CITY PLANNING COMMISSION

- APPLICATION:
- A. Negative Declaration
 - B. Major Project's Special Permit to develop a fourteen story, 172, 896 square foot office building with parking for 151 vehicles on 12,800 developed square feet in the Central Business District- Special Planning District (C-3) zone.
 - C. Special Permit to decrease required parking from 228 spaces to 151 spaces (34 percent reduction).
 - D. Special Permit to allow attendant parking.
 - E. Variance to encroach in the public right-of-way to construct a subterranean parking garage.

LOCATION: 830 L Street

APPLC. NO. P87-456 MEETING DATE March 10, 1988 ITEM NO 24

L STREET ELEVATION

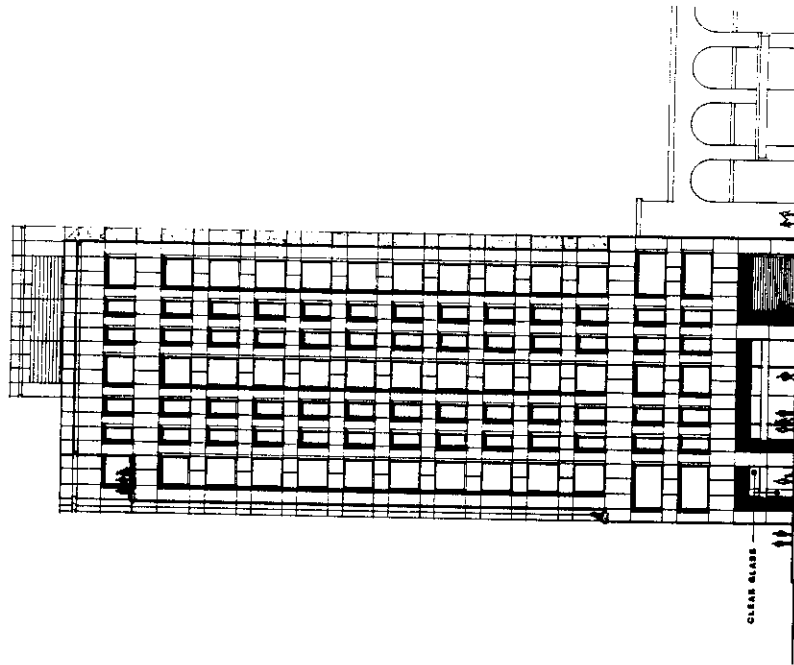
3. an open metal grill pull down door is recommended in the L Street entrance to the parking facility. The interior area of the garage entry visible from the sidewalk shall be finished and painted to match the color of the building exterior; pull down doors facing the alley may be solid rather than open grille work but should be painted to complement the color of the building;

SOUTH ELEVATION

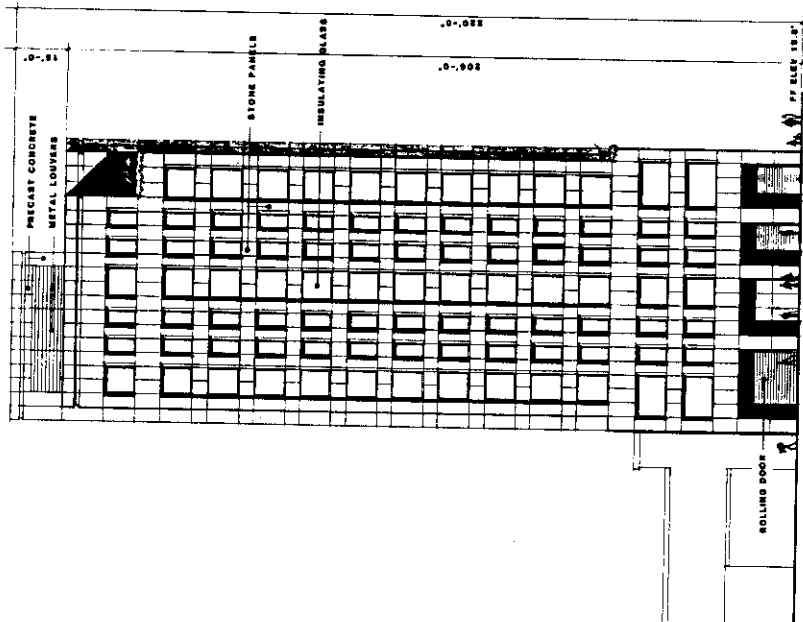
4. materials and design treatment design used on the 9th and L Street facades should also be used on the alley facing facade;
5. the exterior facade of the elevator tower on the west elevation should be enhanced thru a change in surface texture and/or color as suggested in subparagraph 2 above.

FIRST BASEMENT LEVEL
 41 PARKING STALLS
 21 STANDARD
 20 COMPACT

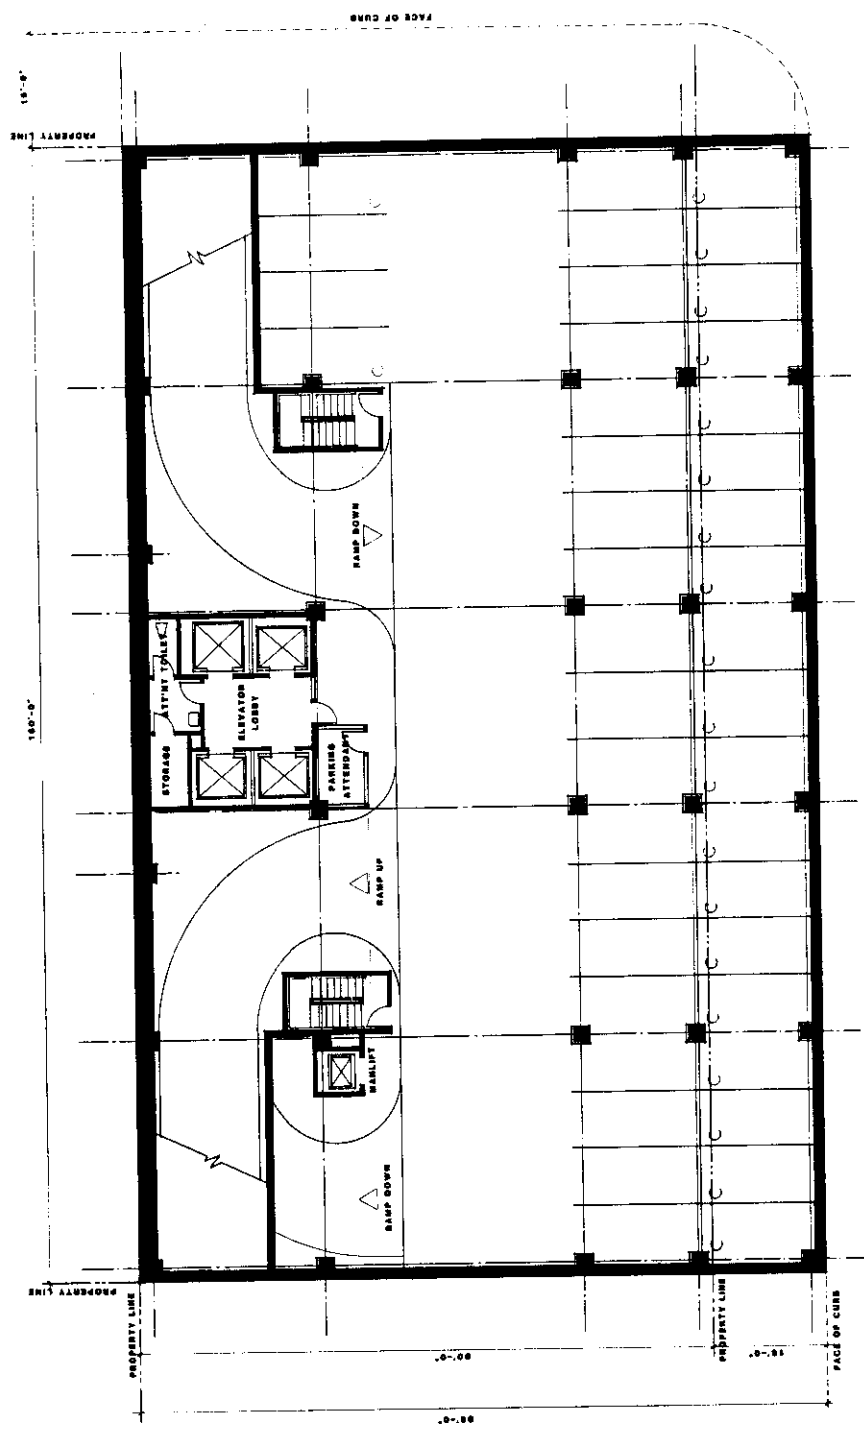
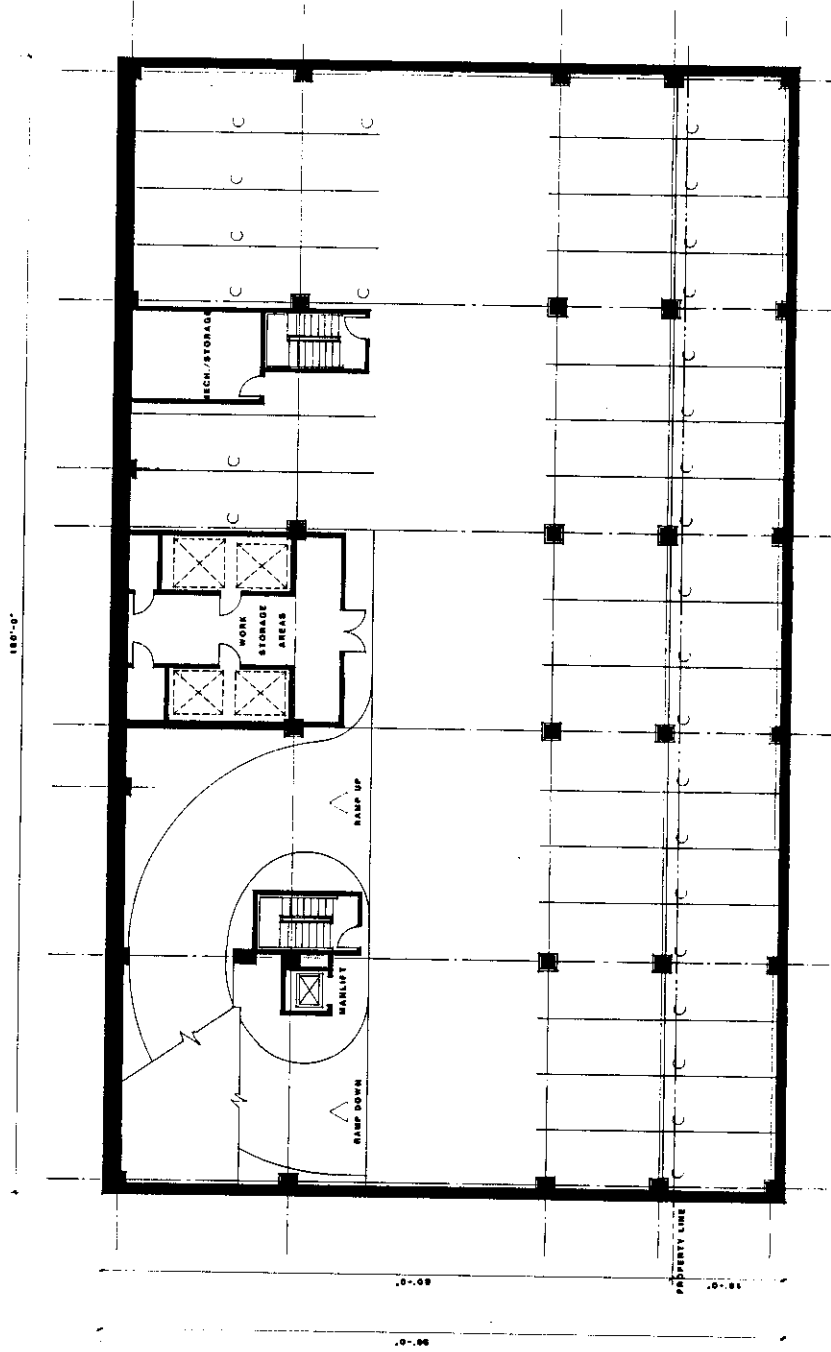
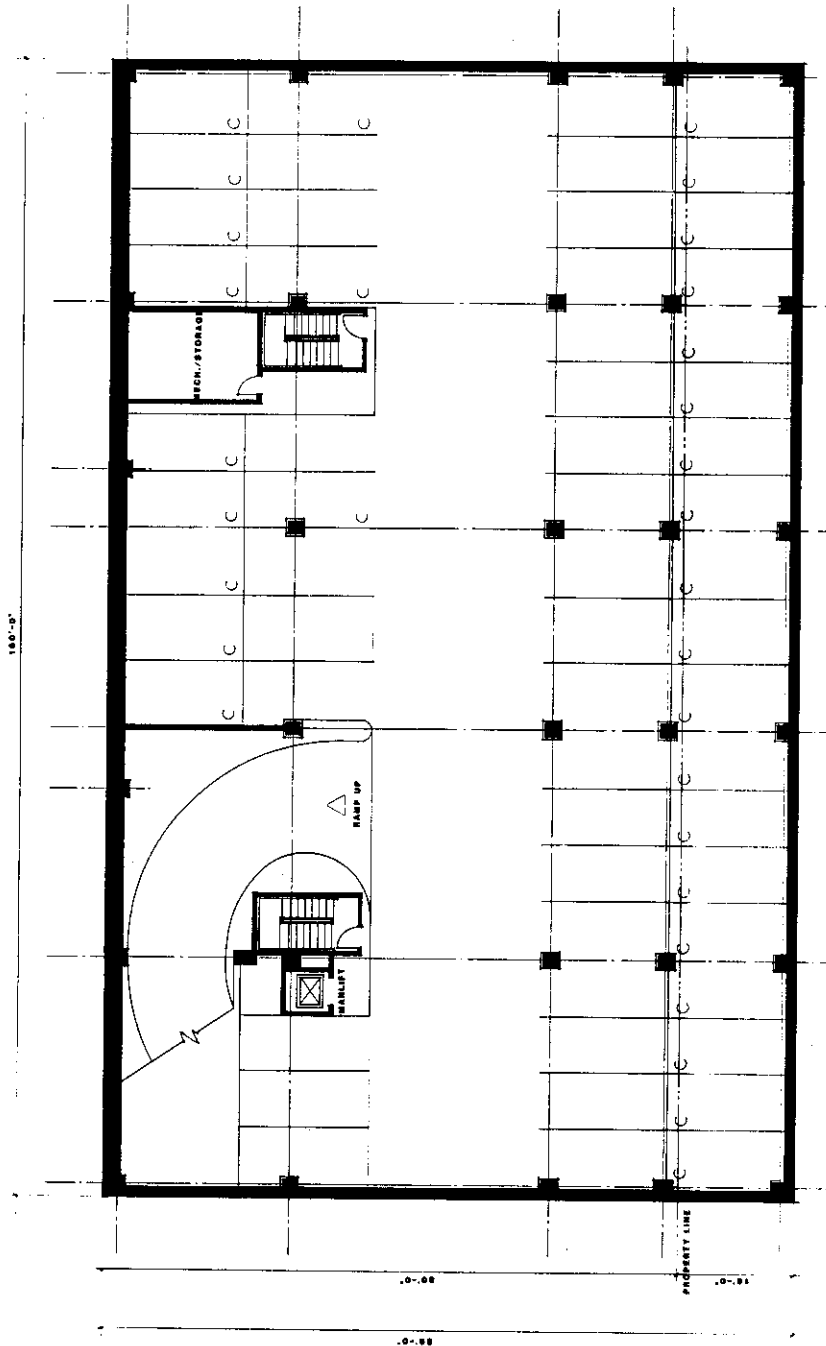
The applicant is requesting a variance to encroach in the public right-of-way to construct a subterranean parking garage. The applicant proposes to use the area below the 9th Street sidewalk for a row of tandem parking. The Department of Public Works indicated that construction in the subject right-of-way may affect the integrity and future maintenance of the adjacent sidewalk, street and utilities within them.

In order to reduce any problems which may arise due to the encroachment, the developer is to coordinate the design of the reconstructed sidewalk with Public Works in the early stages of the project's design. A mitigation measure has been provided which requires the applicant to execute a development agreement (or other acceptable document) to describe maintenance responsibilities of the applicant for the sidewalk, reconstruction of the sidewalk upon removal of the building and any other matters deemed necessary by the Public Works Director.
